ADDENDUM NO. 02

DATE: April 29, 2020

PROJECT: Inglemoor High School Concert Hall + Music Building Project

5 ONE LINE DIAGRAM
SCALE: NTS

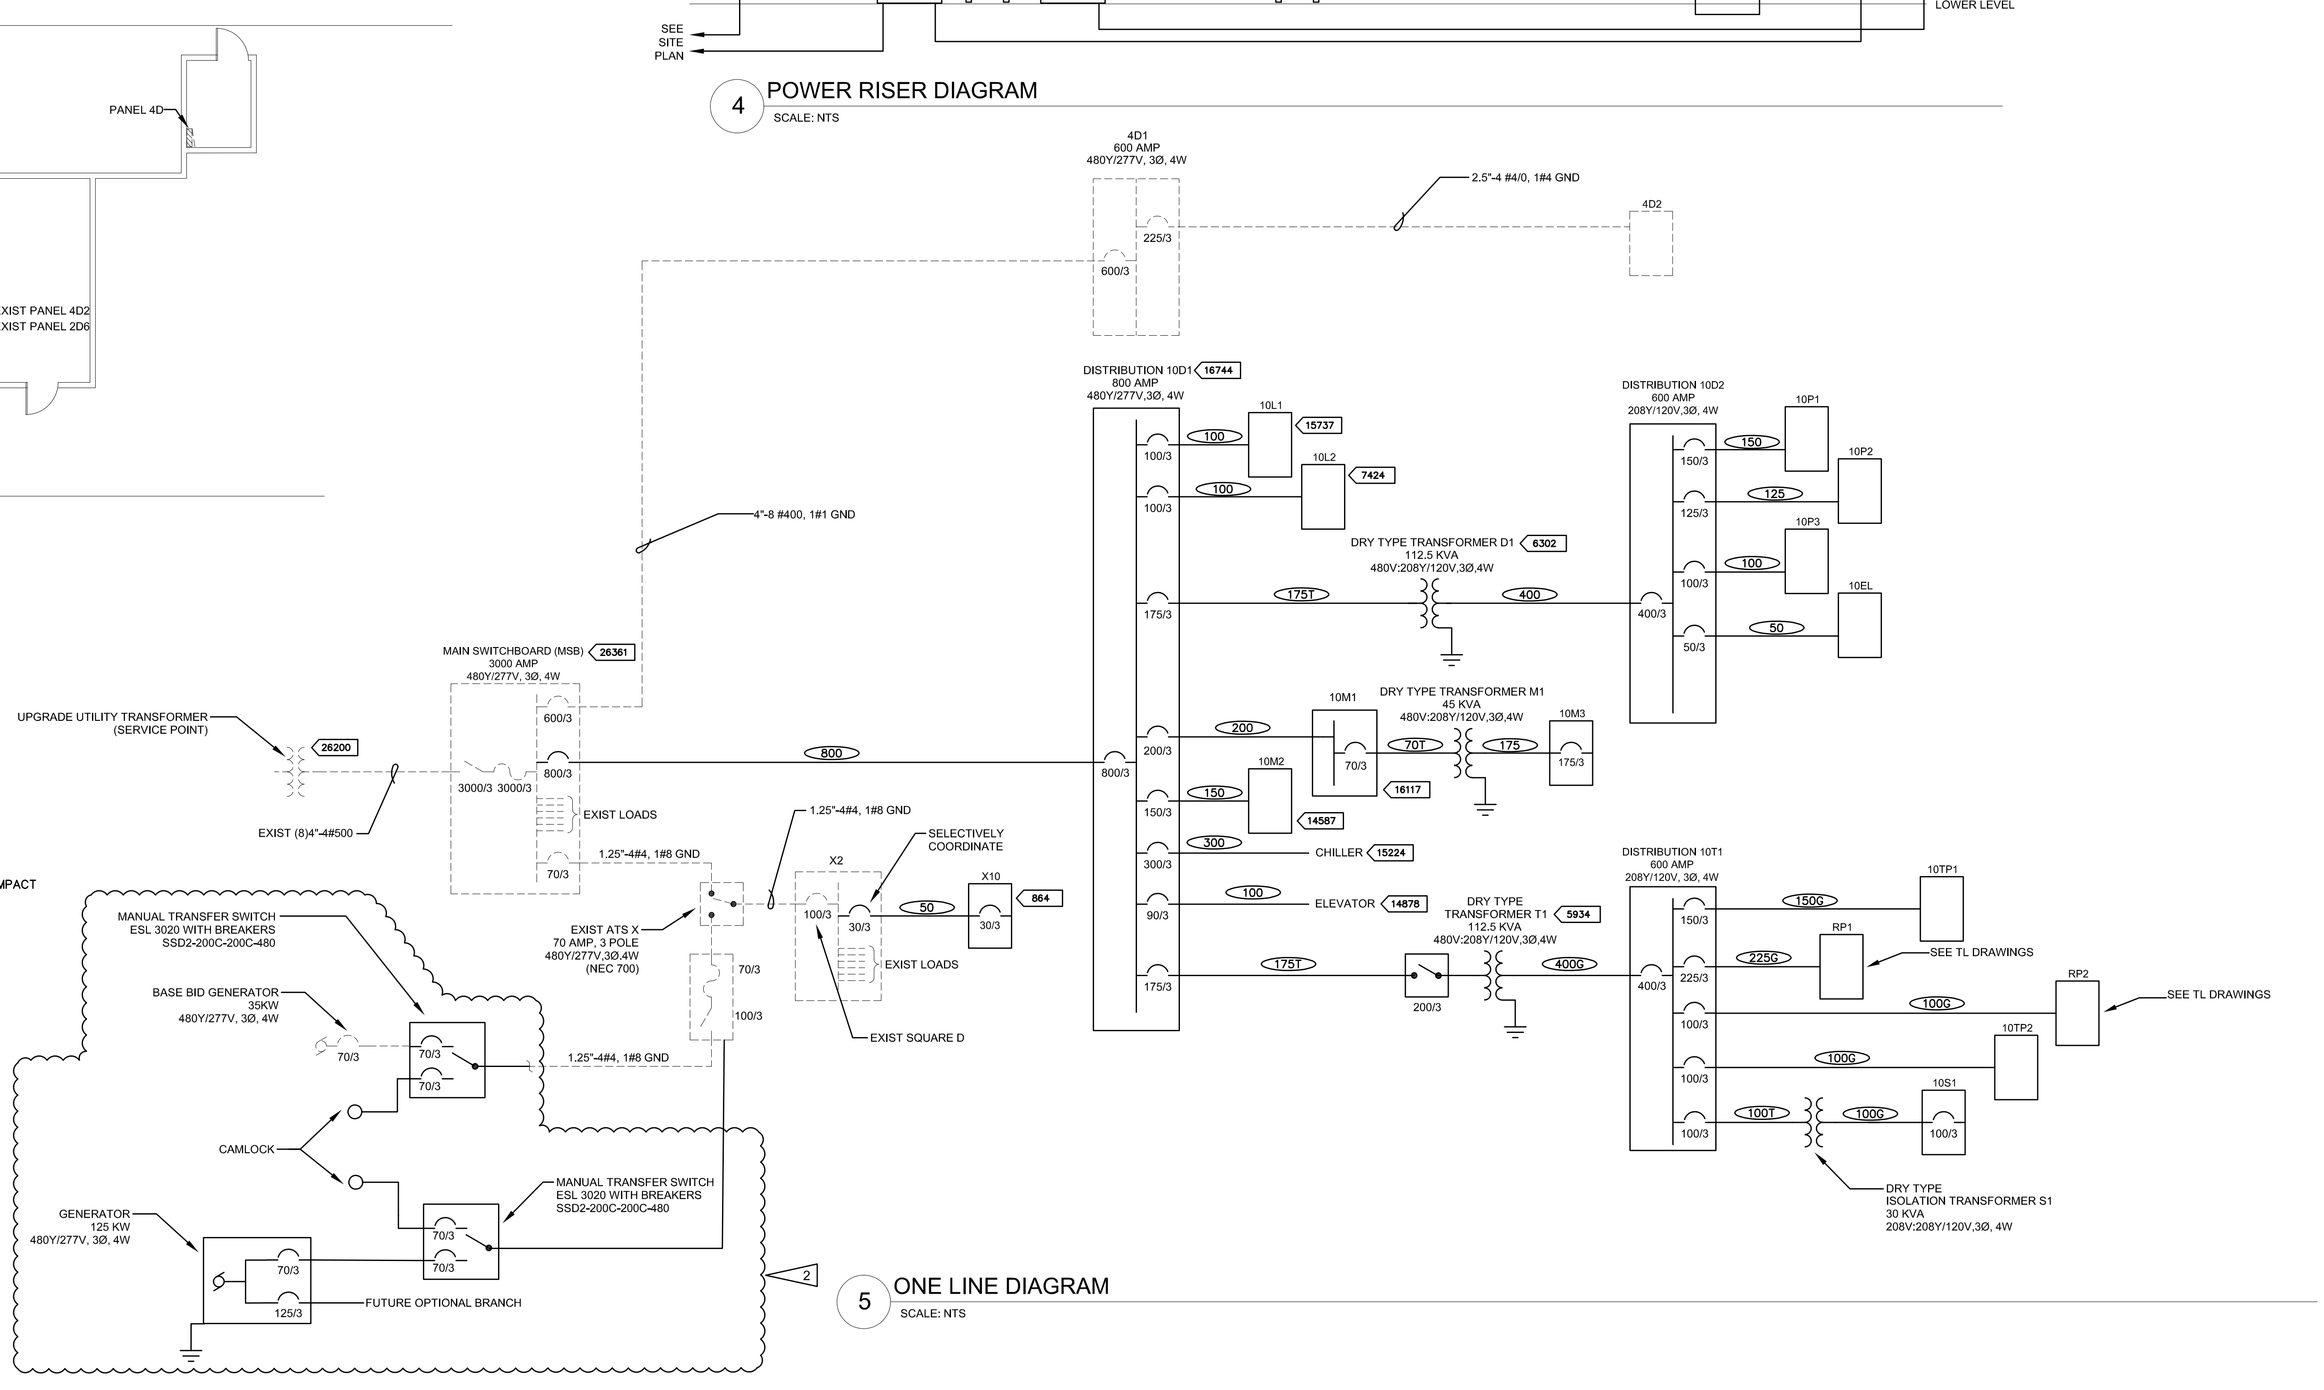
SHEET E6.00 – One Line Diagram Electrical
